Sydenham to Bankstown Metro: Key issues and opportunities

December 2017

Endorsed by Council 28 November 2017

The City of Canterbury Bankstown (Council) provides comment on the Metro Southwest EIS to highlight the significant city shaping opportunities that would be missed if the current plan was constructed as proposed.

Figure 7: TfNSW EIS Concept Plan for Canterbury Station; annotated by Canterbury-Bankstown Council

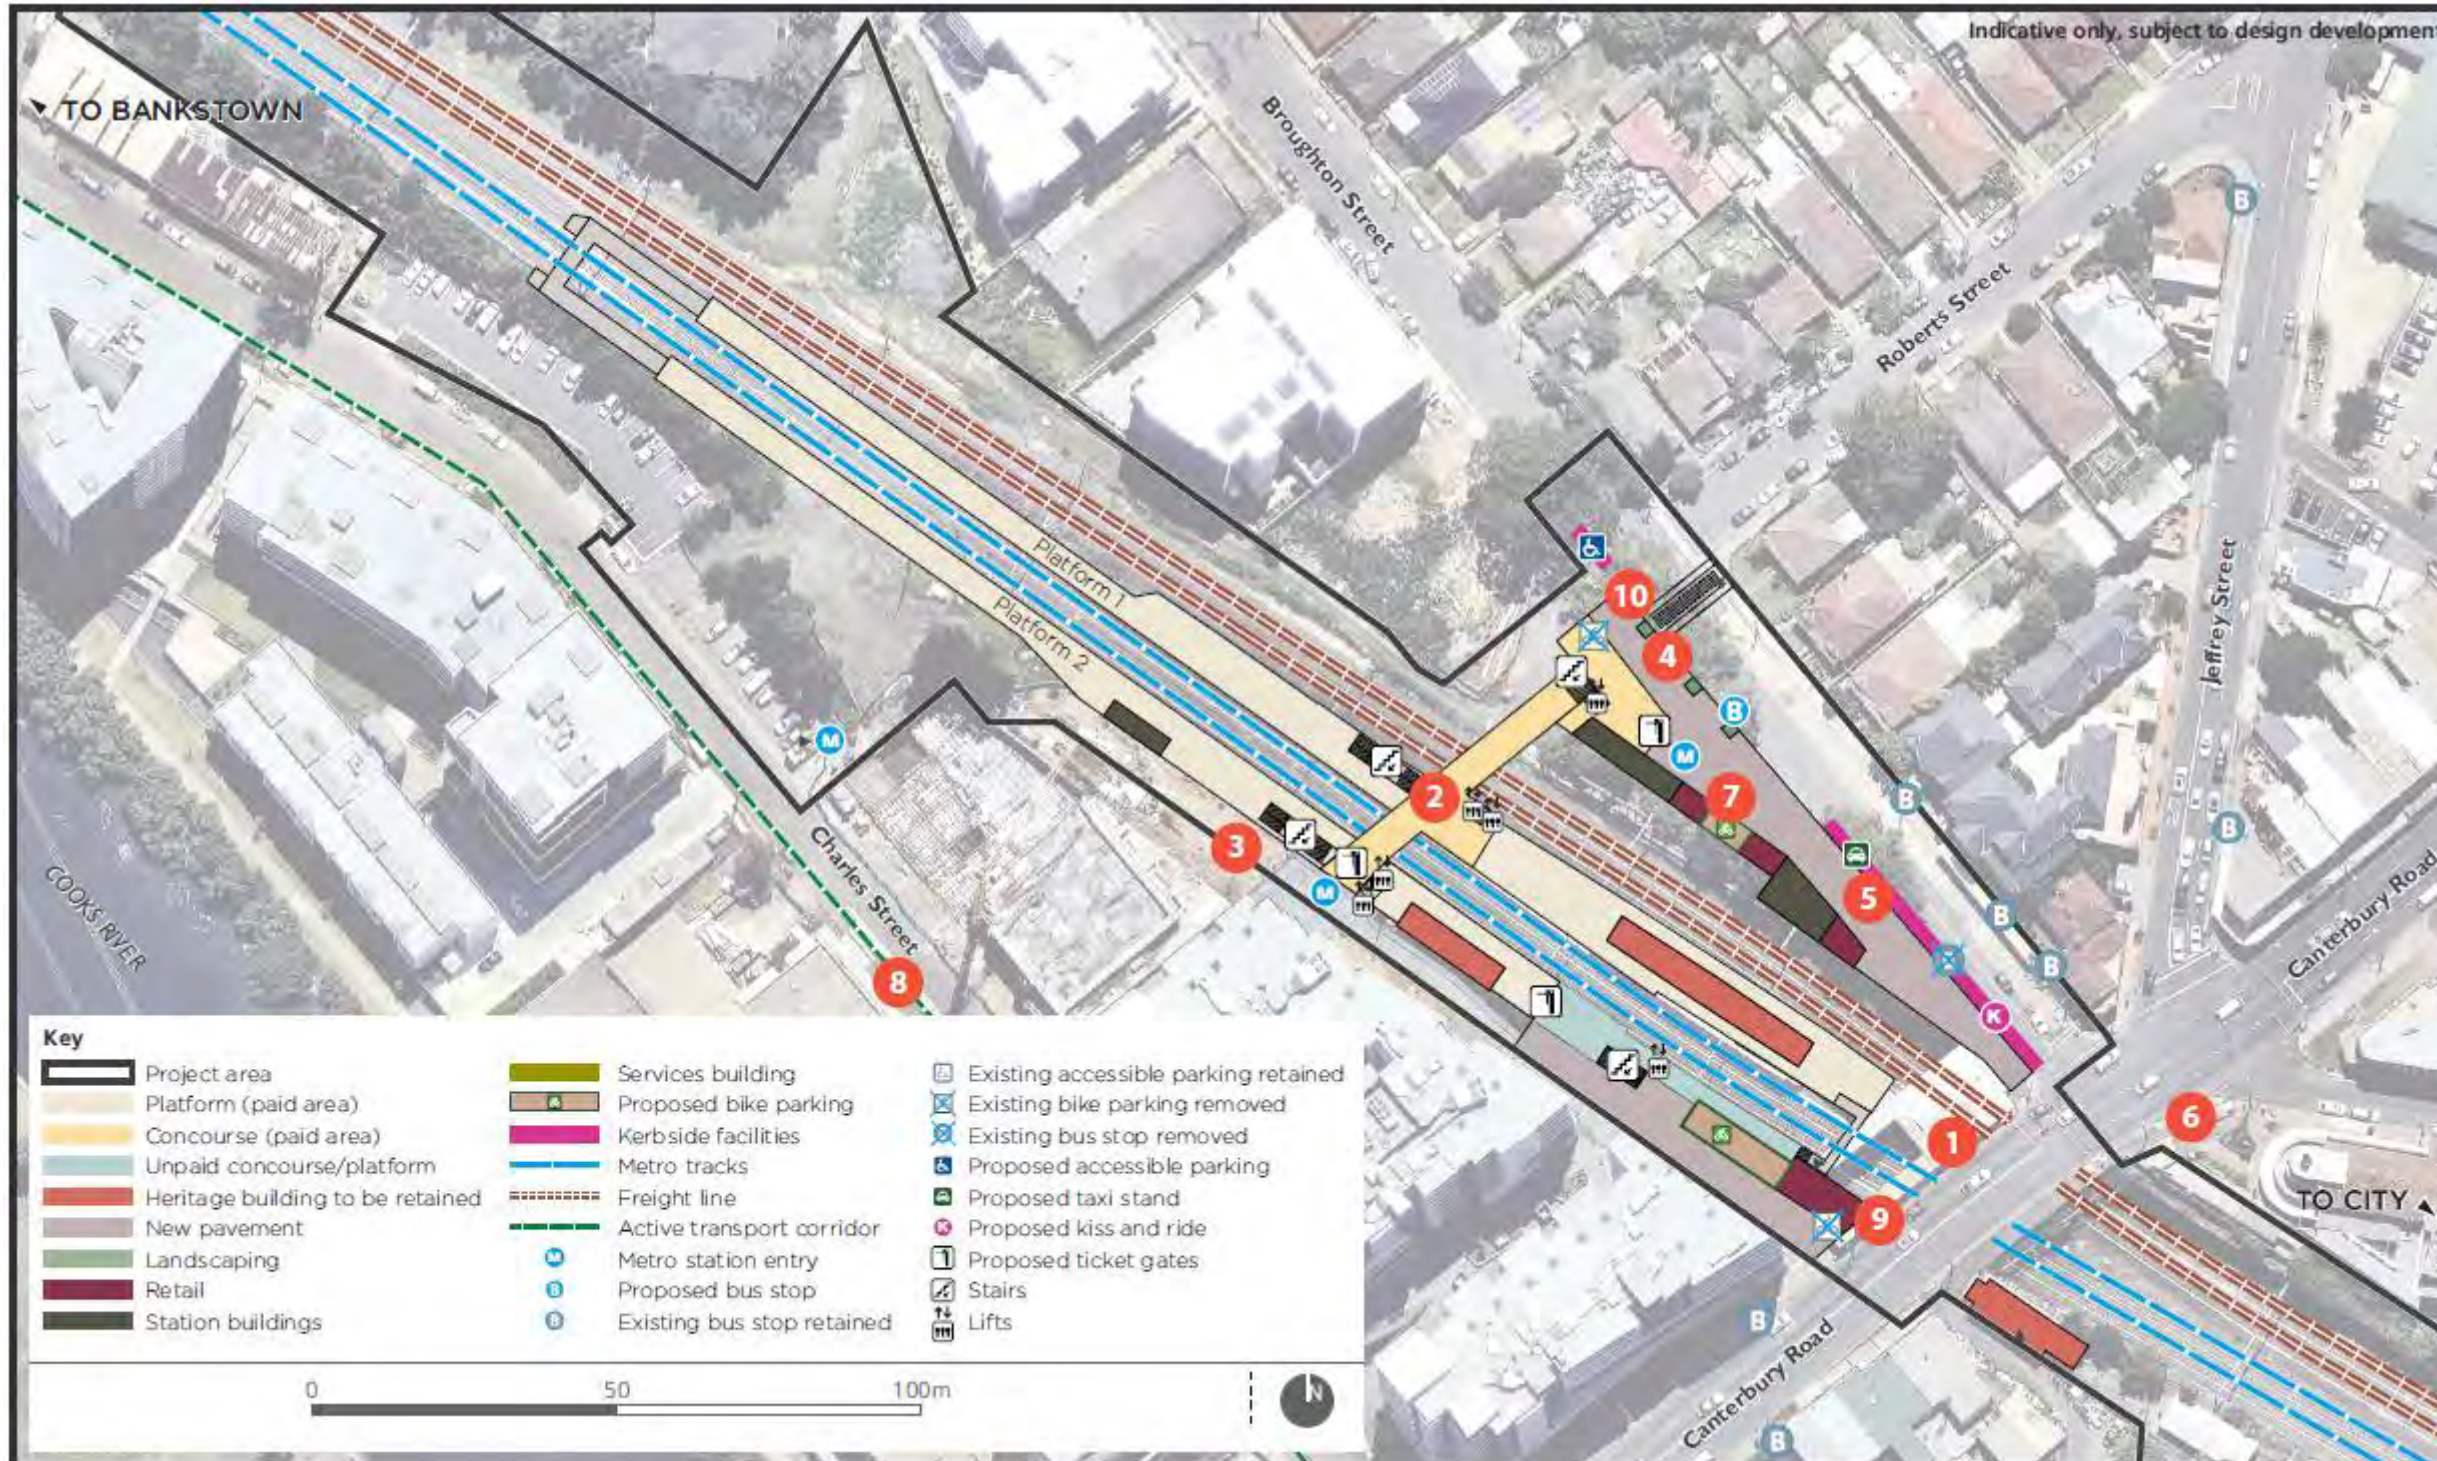
10	Opportunity to Improve Flood Impacts at Canterbury Station / Town Centre	A comprehensive flood impact assessment using models obtained from Council is necessary to evaluate impacts from the project and potential and preferred mitigation options.	<ul style="list-style-type: none"> A comprehensive flood impact assessment using models obtained from Council is necessary to evaluate impacts from the project and potential and preferred mitigation options. Preferred mitigation options are implemented 	<ul style="list-style-type: none"> A comprehensive flood impact assessment using models obtained from Council is necessary to evaluate impacts from the project and potential and preferred mitigation options. Preferred mitigation options are implemented 	Technical Paper 8 – Section 5.2	6 (1) (b)

Figure 8: TINSW EIS Concept Plan for Hurlstone Park Station; annotated by Canterbury-Bankstown Council

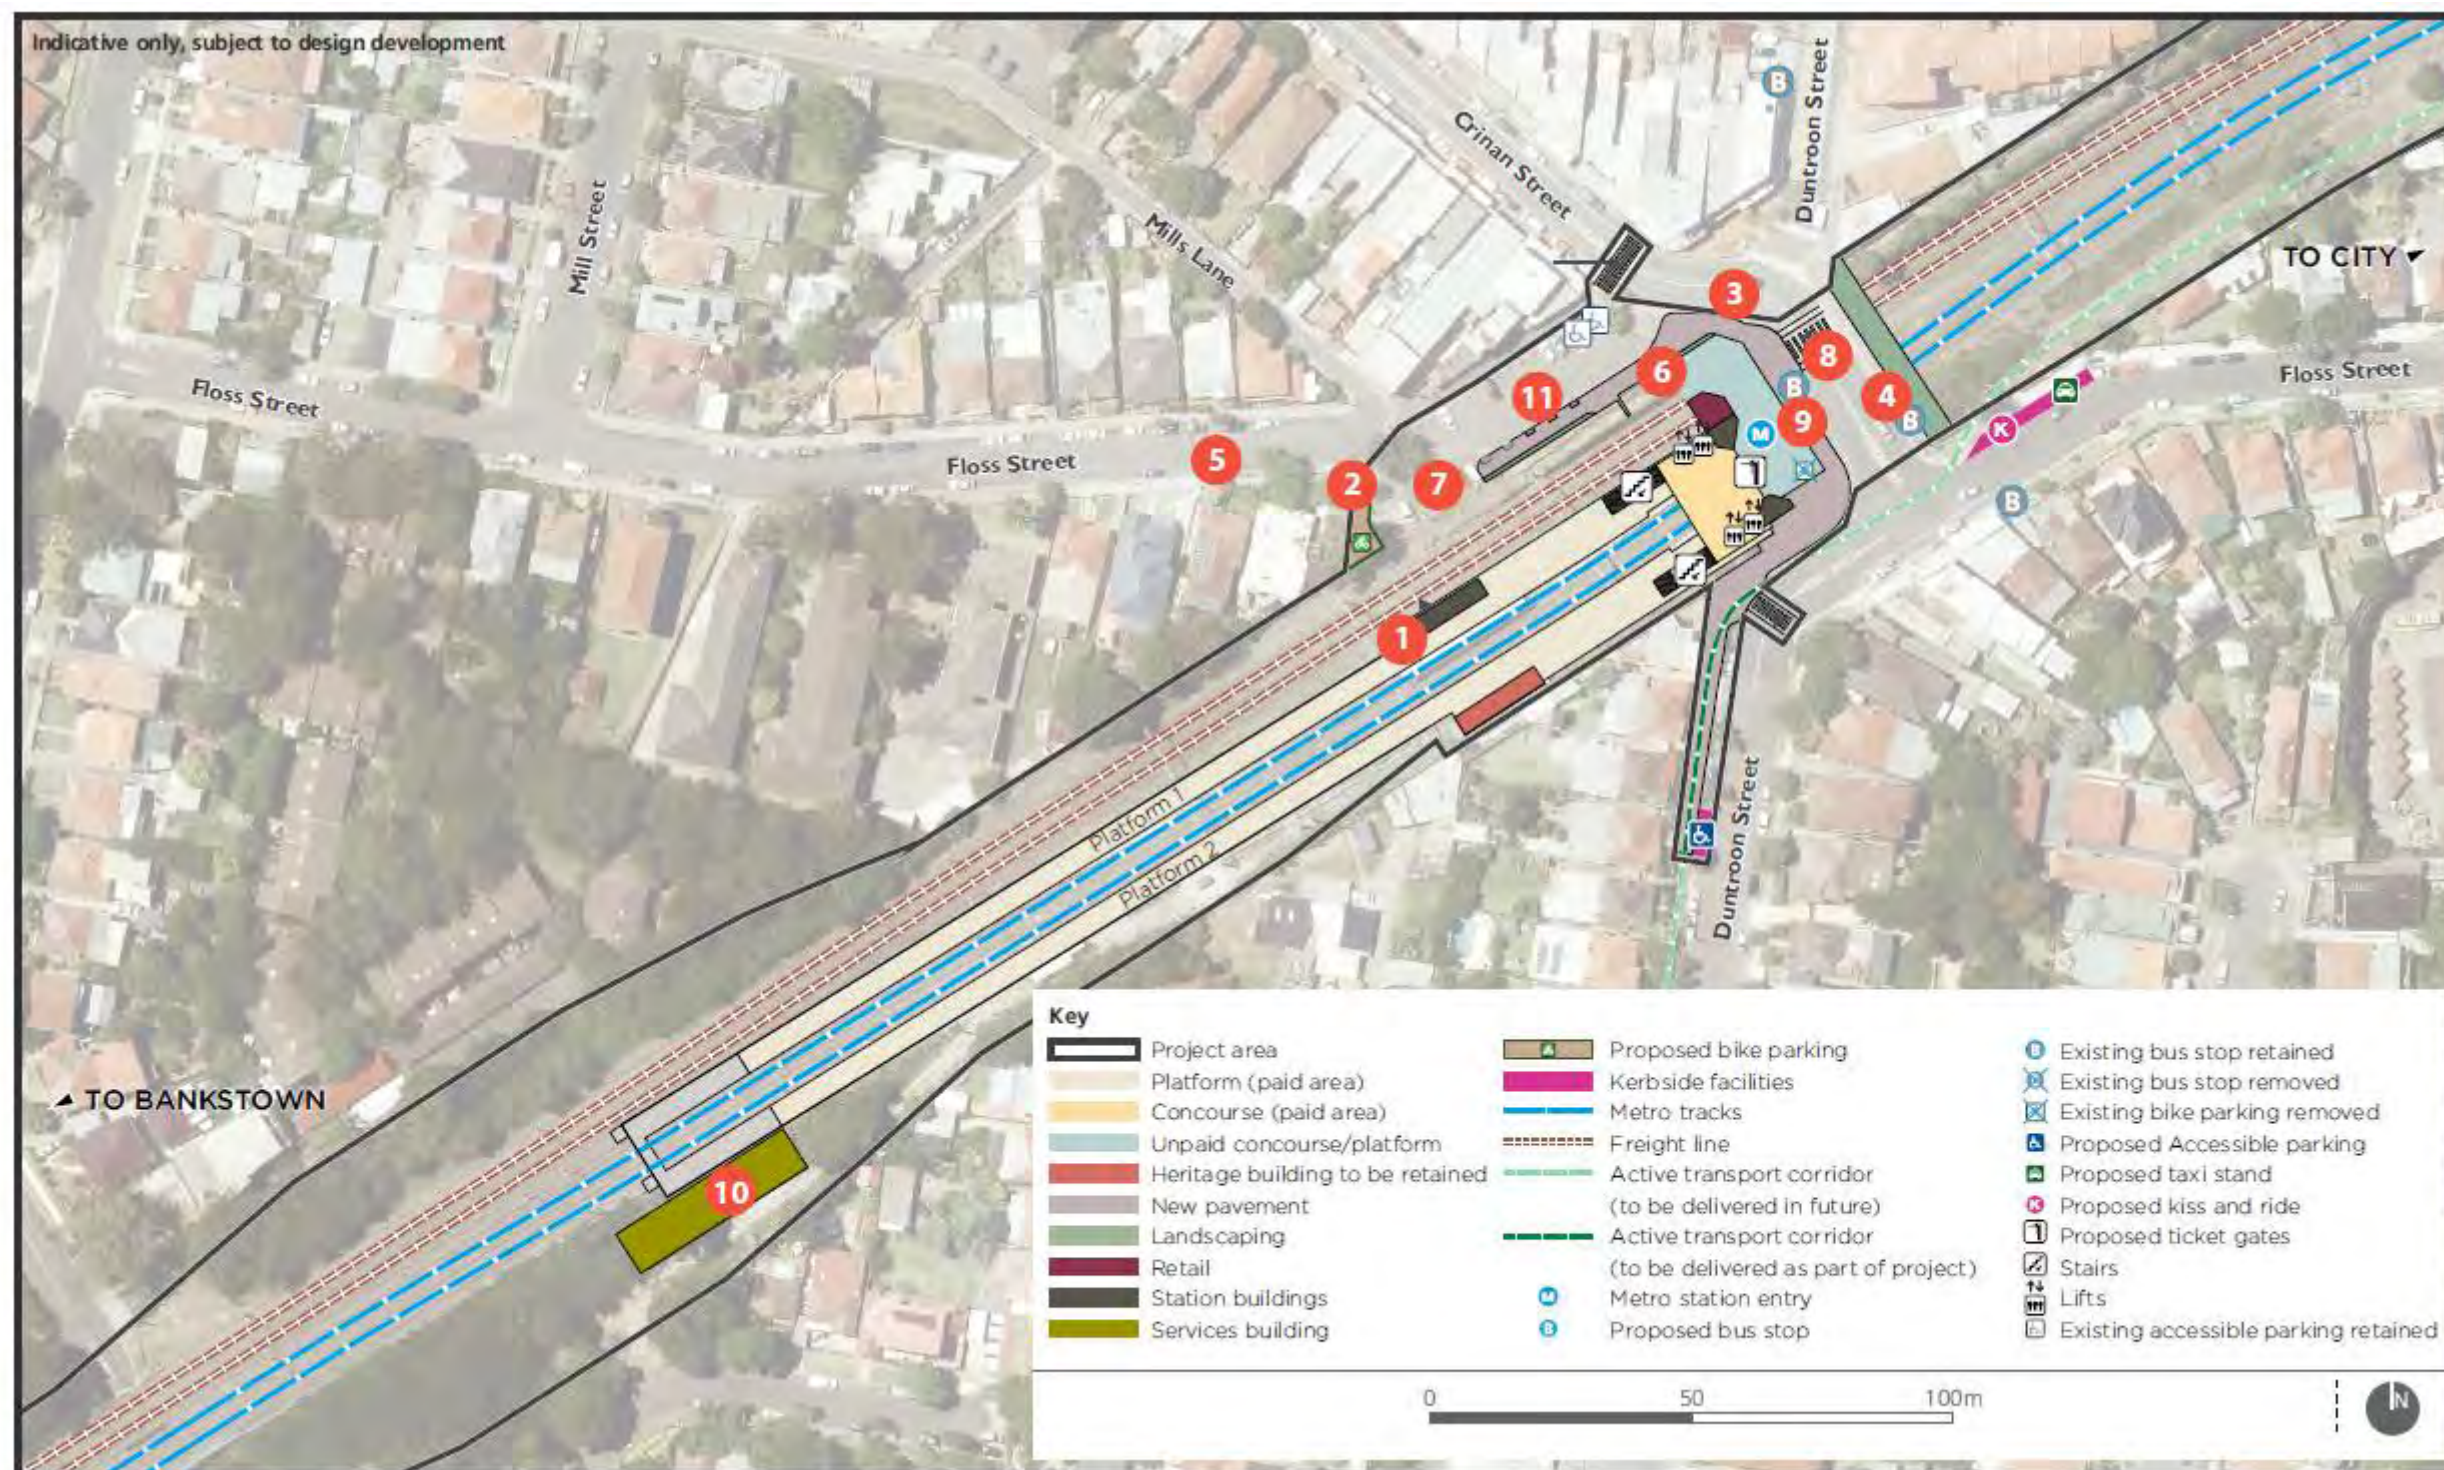
2	Bike parking location serviceability	Review design to locate bike parking at the station entry	<ul style="list-style-type: none"> Additional parking required southern side Bike parking located at station entry 	<ul style="list-style-type: none"> Bike parking located at station entry 	Table 8.4, Figure 8.6	13 (2)
3	Provide a more integrated pedestrian environment connecting Crinan St to Floss Street and Duntroon Streets. Pedestrian priority in front of the station on Crinan Street. <i>Refer to Submission Report Part 2 – Creating Better Places: Opportunities for our Metro Centres</i>	Potential to better connect existing Crinan Street high street and station. Remove proposed additional pedestrian crossings across Crinan Street and Duntroon Street.	<ul style="list-style-type: none"> Refer to Submission Report Part 2 – Creating Better Places: Opportunities for our Metro Centres 	<ul style="list-style-type: none"> Remove Additional pedestrian crossing across Crinan Street from Station EIS plan 	Table 8.4, Figure 8.6	13 (2)

4	Relocate bus bays with bridge widening or indent bus bays into the widened bridge	Clarify in text that there is sufficient bridge width for two parked buses and traffic in each direction at the same time.	<ul style="list-style-type: none"> Clarify in text that there is sufficient bridge width for two parked buses and traffic in each direction at the same time 		Table 8.4, Figure 8.6	13 (2)
5	Flooding issues north of line when area paved - along freight line / Floss St (unofficial channel)	2D flood modelling should be undertaken for the entire length of the works, not focused on one single station (Marrickville only).	<ul style="list-style-type: none"> 2D flood modelling of the entire area impacted. Investigation of Floss Street (unofficial channel). 		Technical paper 8 - Hydrology, flooding and water quality assessment.	Key Issue #6 - Flooding and Hydrology

10	Service building and parking impacts and minimise tree loss <i>Refer to Submission Report Part 2 – Creating Better Places: Opportunities for our Metro Centres</i>	Better locate service buildings and parking. Discretely position services buildings within landscape corridors retaining as many trees as possible.	<ul style="list-style-type: none"> • Minimise any tree loss • Discretely position services building in landscaping • Provide a landscape parking environment including trees 		Table 8.4, Figure 8.6	14(1)-14(4)
11	Convert Floss Street into a shareway and locate kiss and ride her north of the station	Relocate kiss-and-ride from the southern side of the station to the north.	<ul style="list-style-type: none"> • Create a shareway environment on Floss Street. • Relocate kiss and ride to shareway 	<ul style="list-style-type: none"> • Relocate kiss and ride to the carpark on the north side of the station. 	Table 8.4, Figure 8.6	13 (2)
